CATALOG PRODUCT NOTIFICATION

Date:	July 24, 2018		
Customer Part Number:	1297-1325-2-ND	Würth Electronics Midcom Part Number:	750316796
Customer Name:	Digikey	Würth Electronics Midcom Inside Sales Rep:	Theresa Tesch
Customer Contact:	Morgan Ness

Description and Purpose of Change(s):

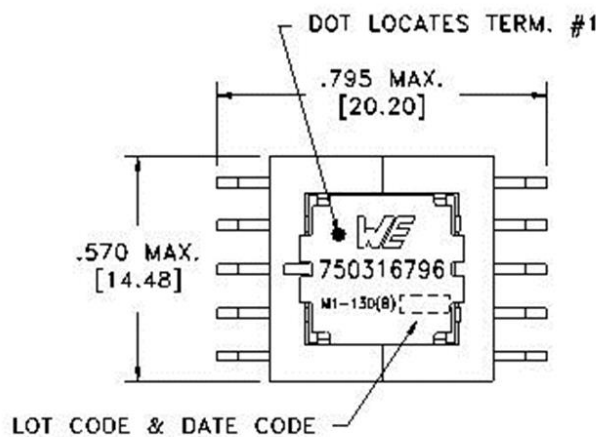
Updating the part to have a Class B Electrical Insulation System on its specification sheet and marked on the part. Also added the clarification that the part is functional insulation only. There was no component changes to the part to meet the insulation system. Please see below what the updated marking on the part will be and the note that will be added to the specification sheet.

UL Recognized Insulation system M1-130(B), E106391. Please note the core is not considered to be dead metal.

Functional insulation only.
